# PINE VIEW ESTATES FILING NO. 1

## STREET PLANS

#### EL PASO COUNTY, COLORADO

PINE VIEW ESTATES  
FILING NO. 1  
STREET PLANS

SHEET: 2 OF 3

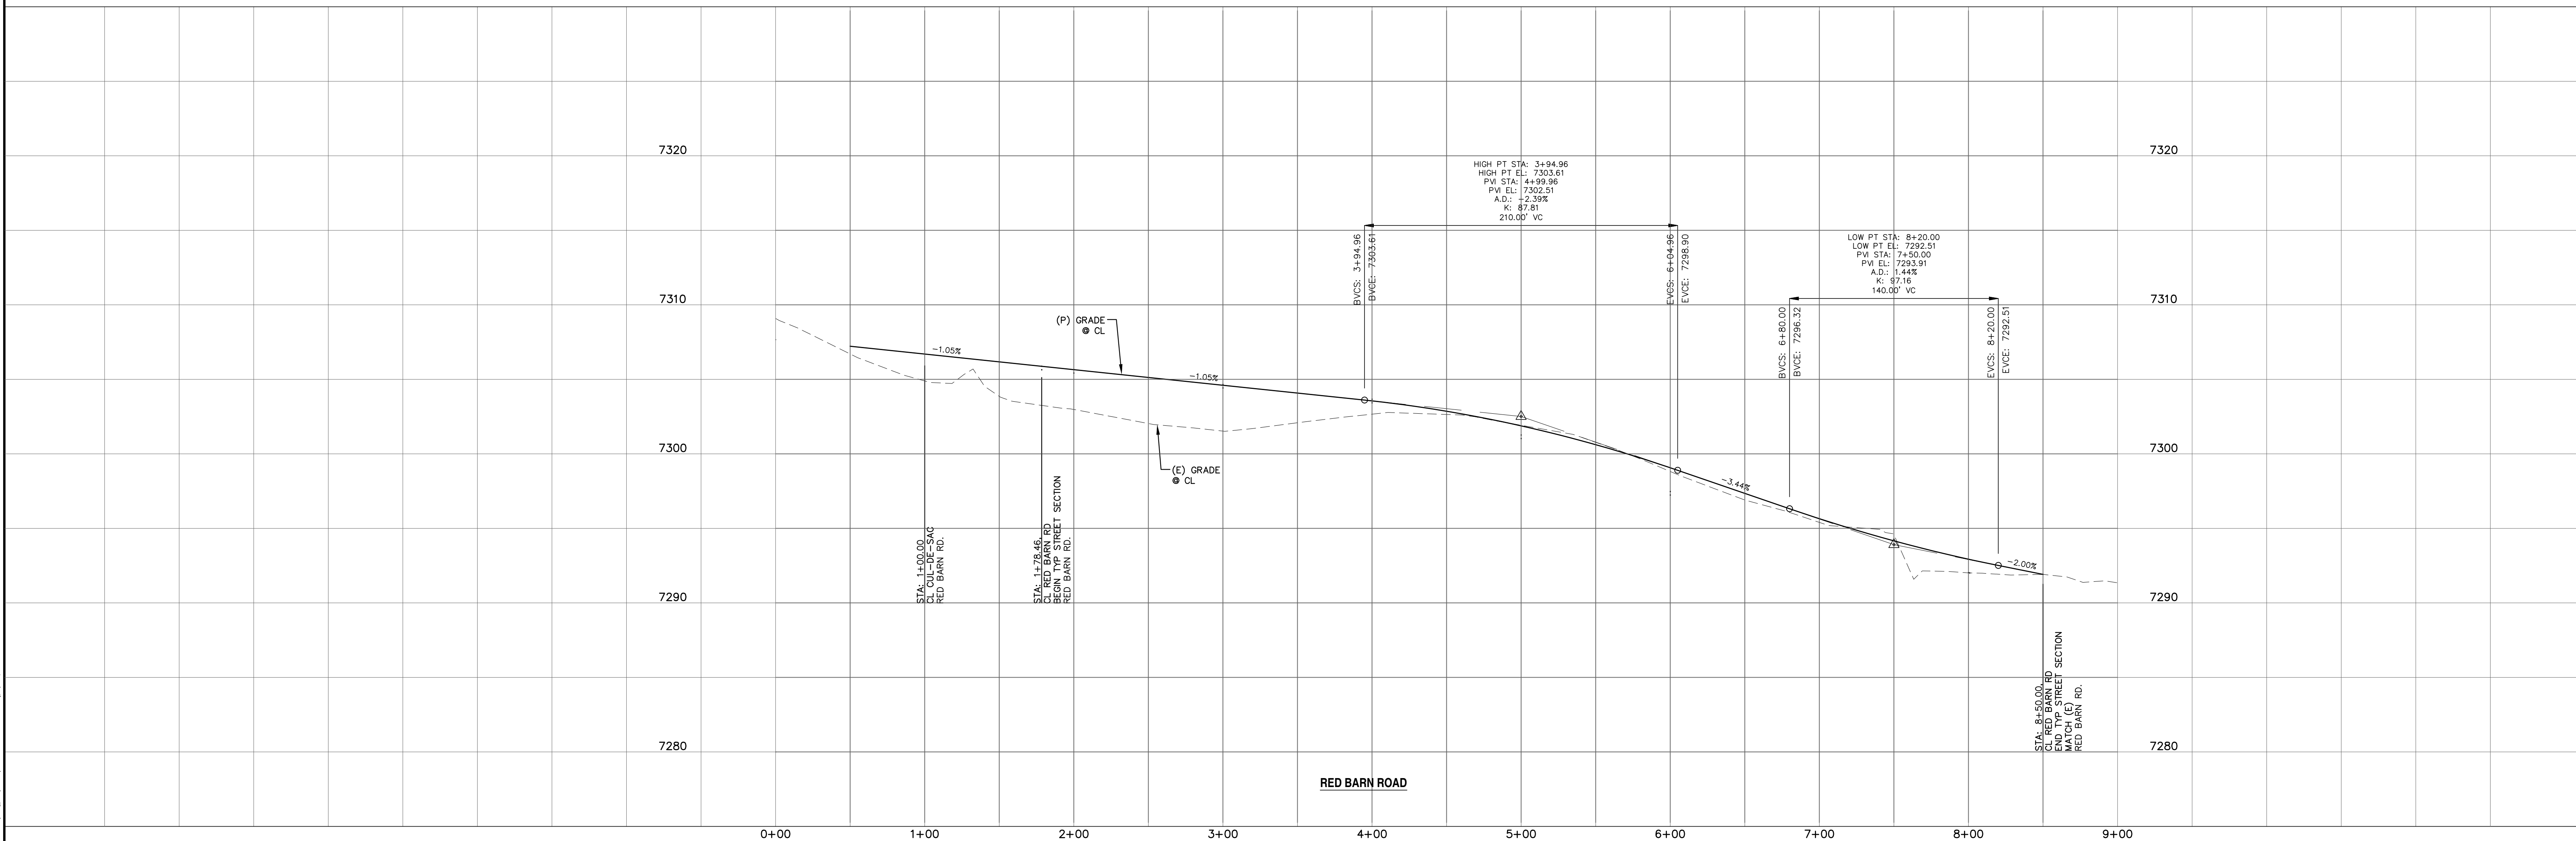
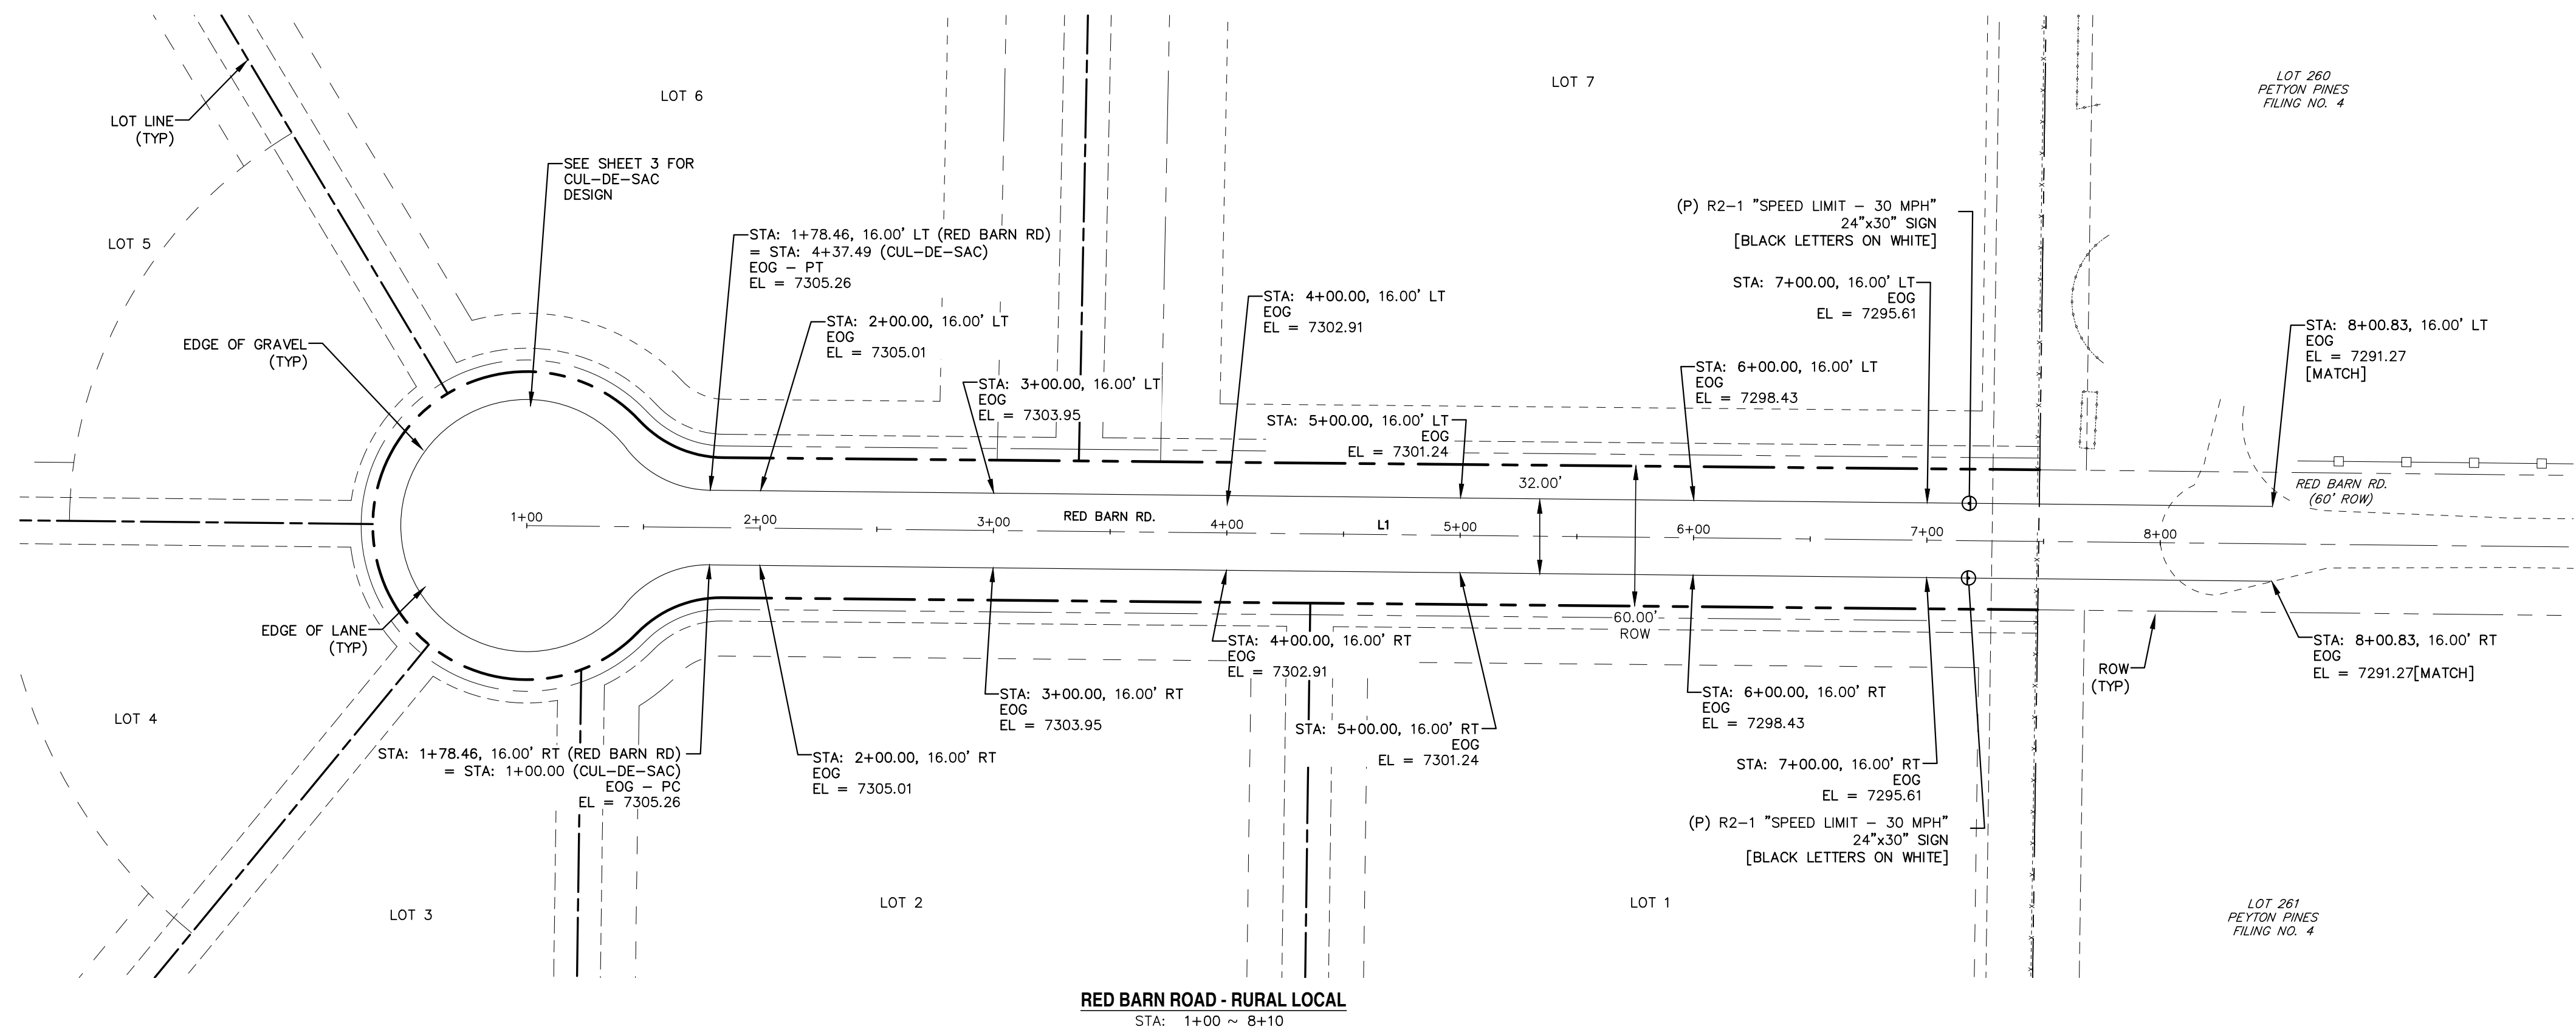
6:1 per county standard detail

Please label as RURAL GRAVEL LOCAL. Please also revise the title on the cross section detail on the GEC
